Top Flite B-25 Mitchell ARF Product Improvement

Please refer to this addendum when you get to the steps in the instruction manual noted below.

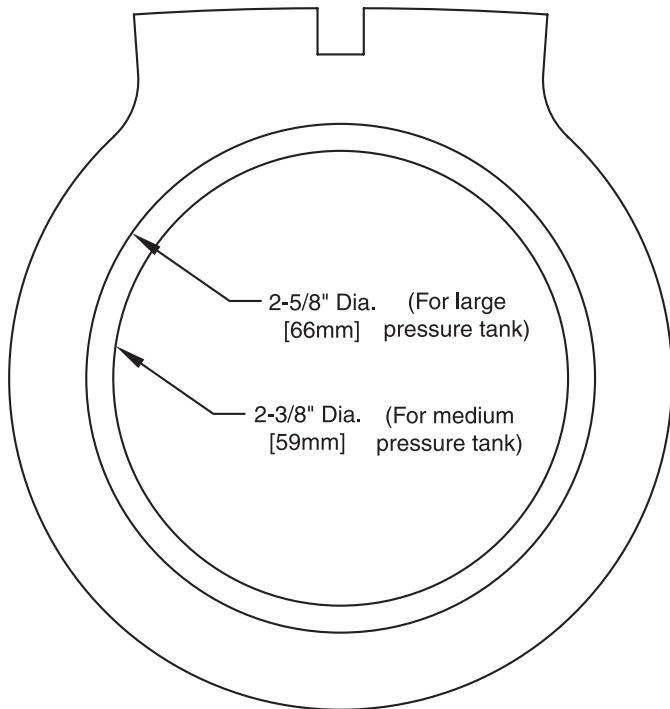
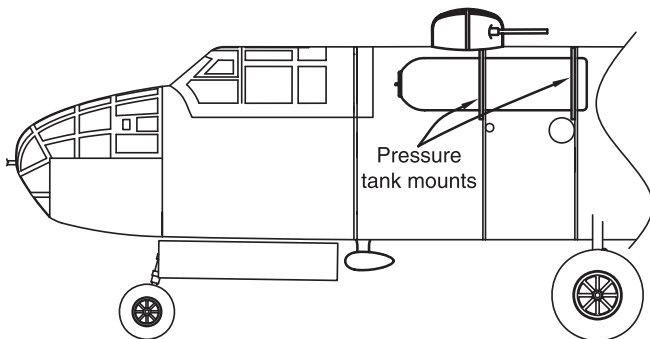
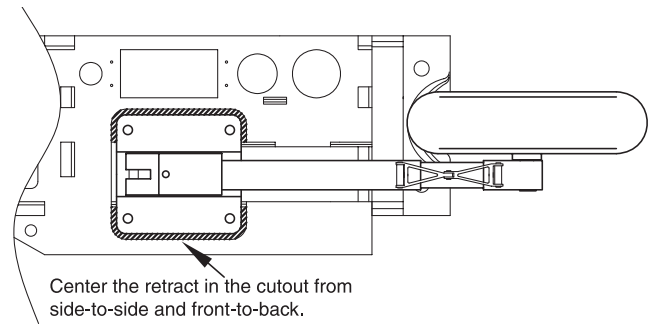
Glue two mounts to the tops of the formers in the fuselage. Glue the pressure tank in the mounts with RTV silicone.

The Air Control Kit for the Robart retractable landing gear specified on page 4 in the instruction manual is incorrect. It contains the wrong pressure tank which is too large. Instead of ROBQ2305 (157VRX Large Deluxe Air control Kit), the correct number should be ROBQ2307 (188VRX Standard Deluxe Air Control Kit) which contains the small pressure tank.

However, some may prefer to use a larger pressure tank anyway. Once the retract system in your B-25 has been cycled a few times and "broken-in," the small pressure tank will provide 2-3 cycles per charge. A larger pressure tank will provide more cycles. The templates at the top of this page could be used to make mounts from 1/8" [3mm] lite-ply for suspending a medium or large pressure tank from the top of the fuselage behind the cockpit. Two mounts are required.

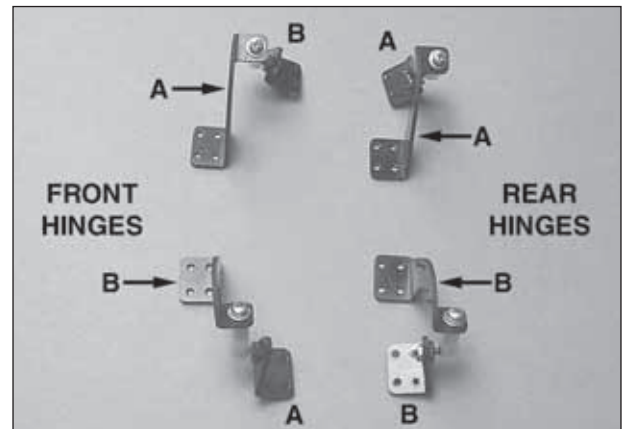
Refer to the above sketch when you get to Page 13, Step 4.

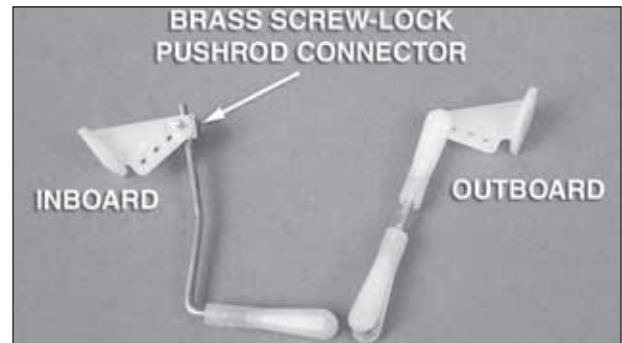
Page 15, Step 9: One of the nacelle hinge assemblies in the photo in the instruction manual is labeled incorrectly. Refer to this photo which is labeled correctly.

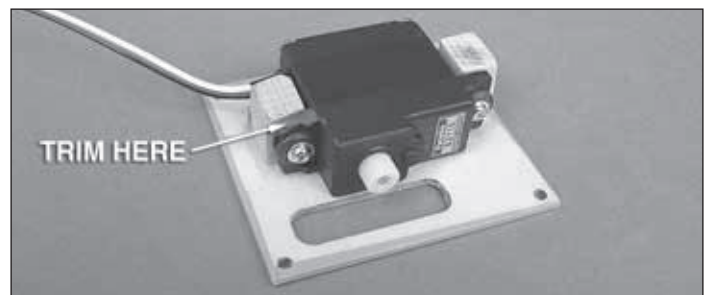
Page 17, Step 13: The door pushrods are labeled incorrectly in the photo in the instruction manual. Refer to this photo which is labeled correctly.
